From: [Mark Ferlisi](#)
To: [Kimberly Verderber](#)
Subject: Editorial Correction Needed to Figure IWB-2500-11
Date: Wednesday, March 6, 2019 10:08:42 AM
Attachments: [image003.png](#)

2010 SECTION XI, DIVISION 1

FIG. IWB-2500-11 PIPE BRANCH CONNECTION
(1 in. = 25 mm)

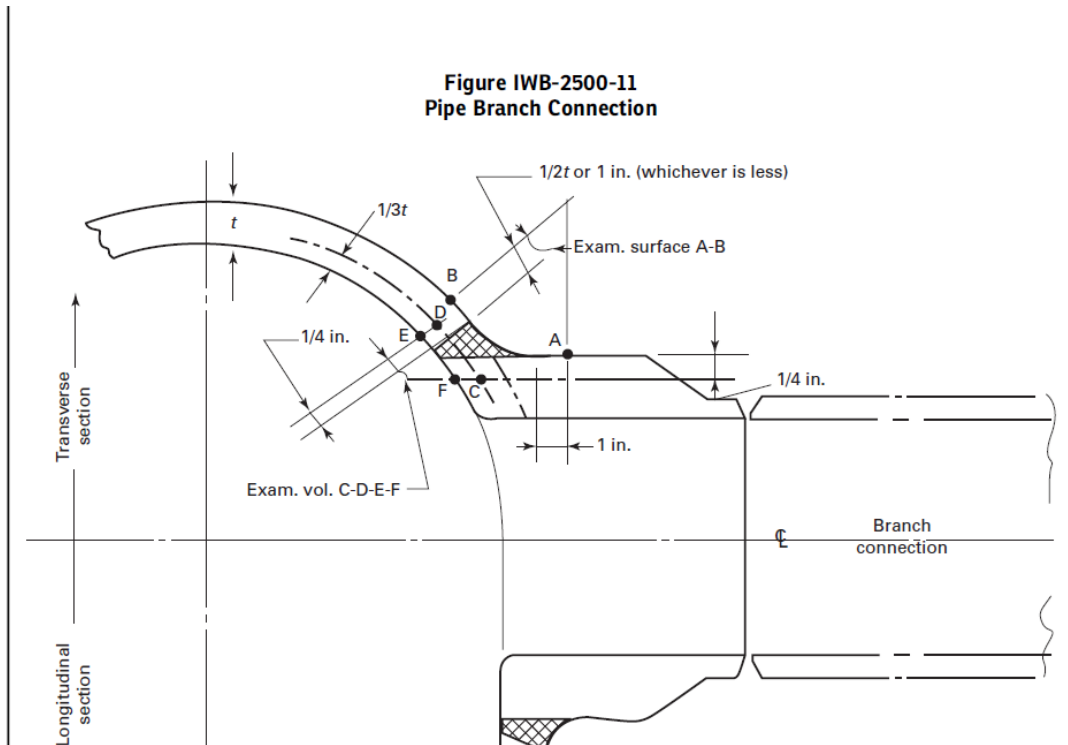
Kim: In the figure below, the leader line arrowhead for "Exam. Surface A-B" should terminate at the vertical line instead of where it is currently shown. Also, the dimension line between the arrowheads for "1/2t or 1 in. (whichever is less)" should actually be shown parallel to the surface of the component (it is currently shown at an angle).

If the original action showed this correctly, then this could be handled as errata. I hesitate to have the committee take this action on as an editorial correction, but we should ensure that this is shown correctly when the 2019 Edition is published.
